DEVELOPMENT REVIEW BOARD REPORT

Meeting Date: May 16, 2019 Item No. 5
General Plan Element: *Character and Design*
General Plan Goal: *Foster quality design that enhances Scottsdale as a unique southwestern desert community.*

**101 Mega Raintree
4-DR-2019**

Request: Request approval of the site plan, landscape plan and building elevations for a new commercial development with approximately 8,500 square feet of building area, an ATM with drive-through service, and a restaurant with drive-through service, all on a 1.14-acre site in the Northsight Crossing shopping center.

RETAIL - PRELIMINARY SITE PLAN

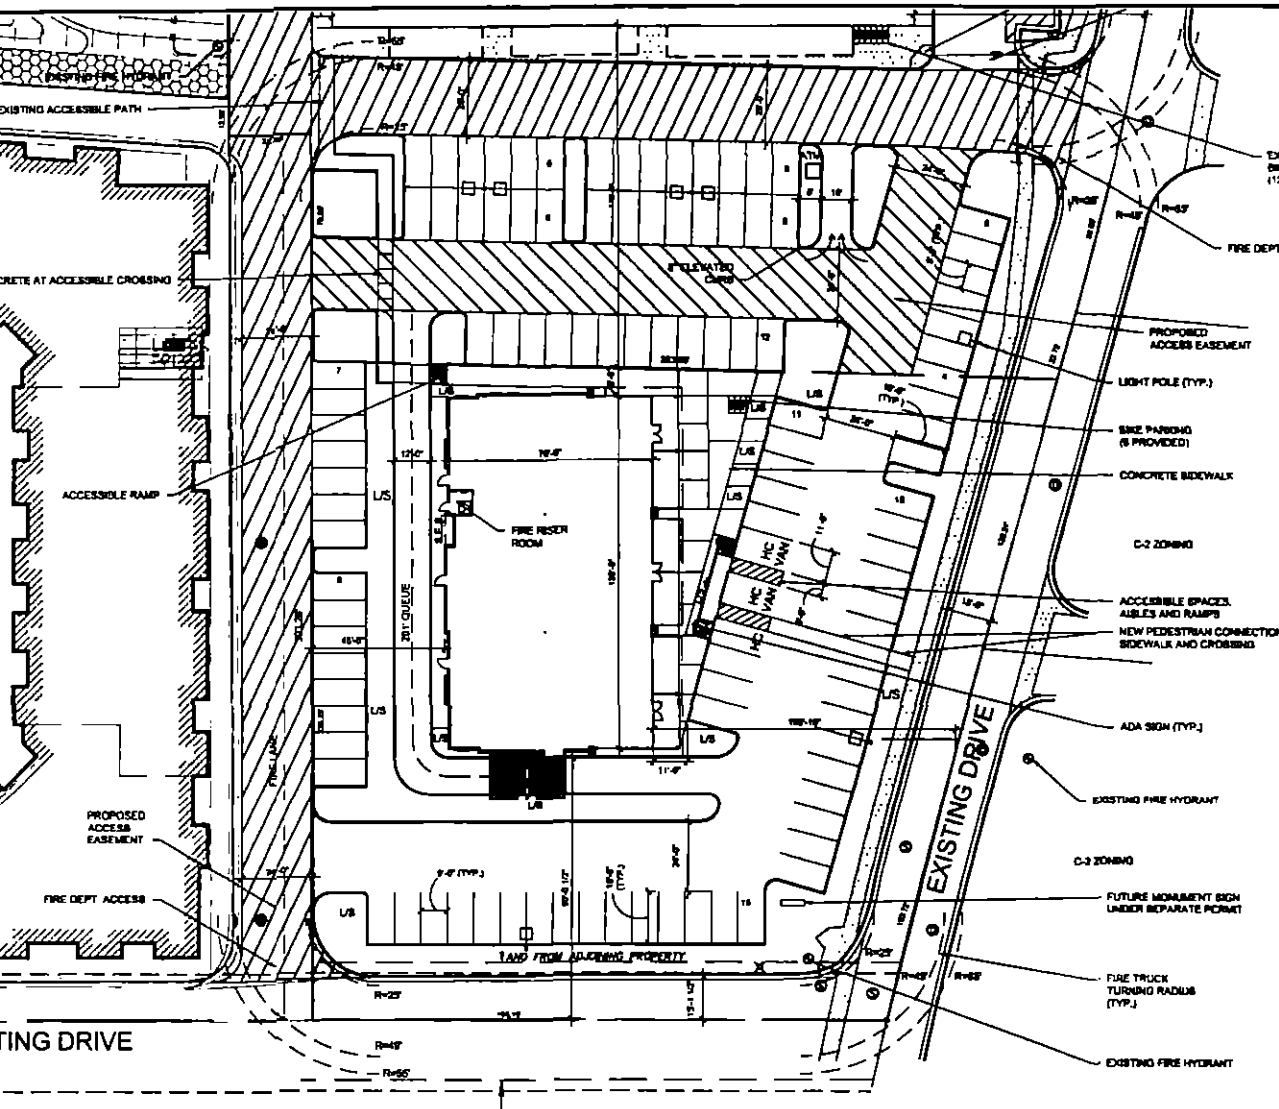
7. *Prior to the issuance of any building permit for the development project, the property owner shall modify the project plans to provide a minimum five (5) foot wide sidewalk along the south side of the project to connect the southwest corner of the site to the existing sidewalk along the north/south drive aisle on the eastern portion of the site.*

8. *Prior to the issuance of any building permit for the development project, the property owner shall modify the project plans to provide an additional sidewalk connection from the new sidewalk noted in Stipulation #7 above to the front of the building. New sidewalk connection shall be a minimum of five (5) feet in width and be protected on either side by a landscape area when adjacent to parking spaces.*

9. *Prior to the issuance of any building permit for the development project, the property owner shall modify the project plans to provide landscape areas adjacent to either side of the pedestrian connection shown on the site plan that connects the building to the north/south sidewalk along the eastern side of the development site.*

10. *Prior to the issuance of any building permit for the development project, the property owner shall modify the project plans to provide a screen wall of a minimum height of four (4) feet along the west side of the drive-through lane to screen vehicles from off-site, to the satisfaction of the DRB Coordinator.*

- b. A minimum 24-foot-wide emergency services and cross-access easements from parcel north of subject parcel to provide for access to development project including drive thru aisle.

SHEET TITLE	EXTERIOR ELEVATIONS
DRAWN DATE	
CHECKED BY	
PROJECT NUMBER	
DRAWING NO.

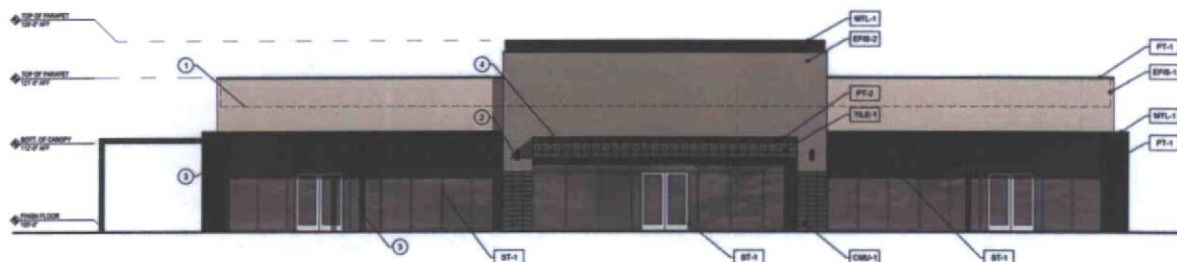
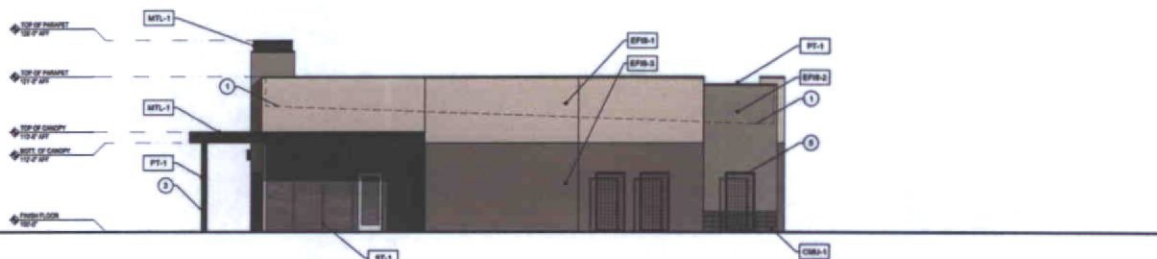
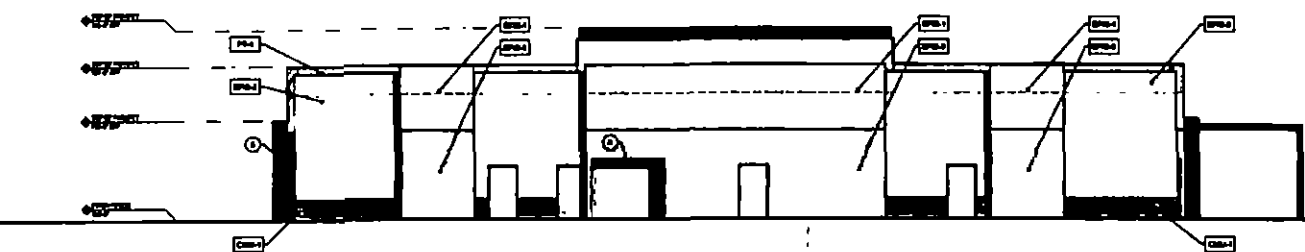
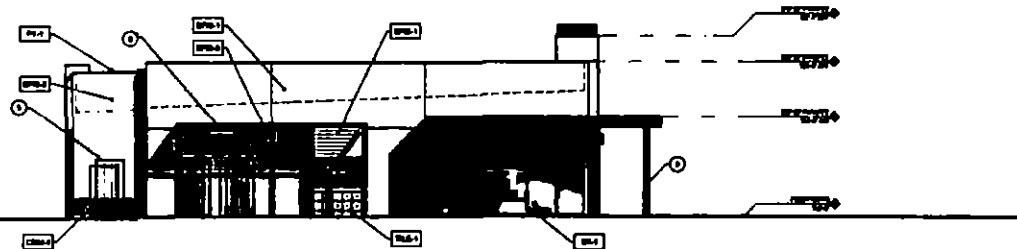
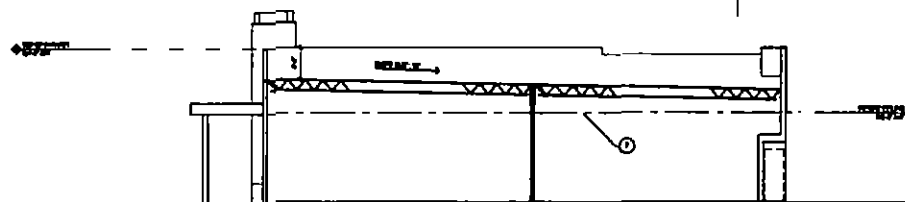
2. *All exposed steel columns, beams, and frames shall be revised to be hollow steel section with a minimum cross-sectional dimension to 12 inches.*

4. *All exterior window glazing shall be recessed a minimum of fifty (50) percent of the wall depth, including glass windows within any tower/clerestory elements. The amount of recess shall be measured from the face of the exterior wall to the face of the glazing, exclusive of external detailing. With the final plan submittal, the developer shall provide head, jamb and sill details clearly showing the amount of recess for all window types.*

5. *All exterior doors shall be recessed a minimum of thirty (30) percent of the wall depth, the amount of recess shall be measured from the face of the exterior wall to the face of the glazing, exclusive of external detailing. With the final plan submittal, the developer shall provide head, jamb and sill details clearly showing the amount of recess for all door types.*

SHEET TITLE
LOT 4 RETAIL
LANDSCAPE PLAN

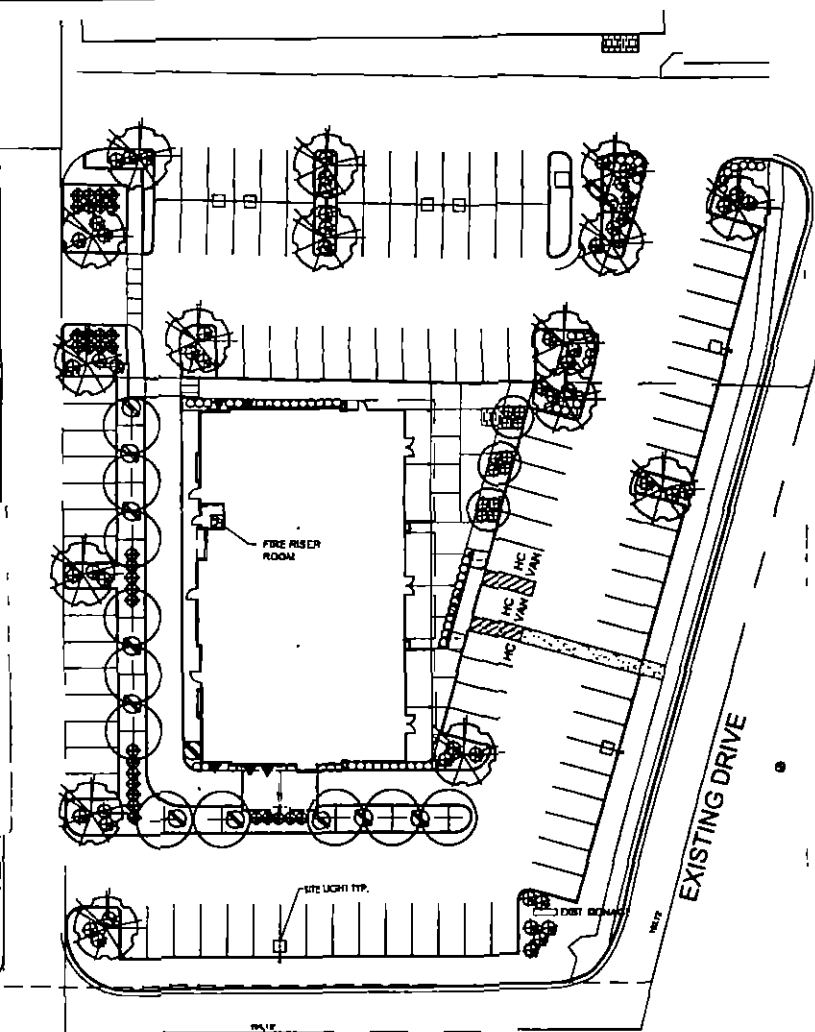
- 12. Prior to the issuance of any building permit for the development project, the property owner shall submit landscape improvement plans that demonstrate how the salvaged vegetation from the site will be incorporated into the design of the landscape improvements.
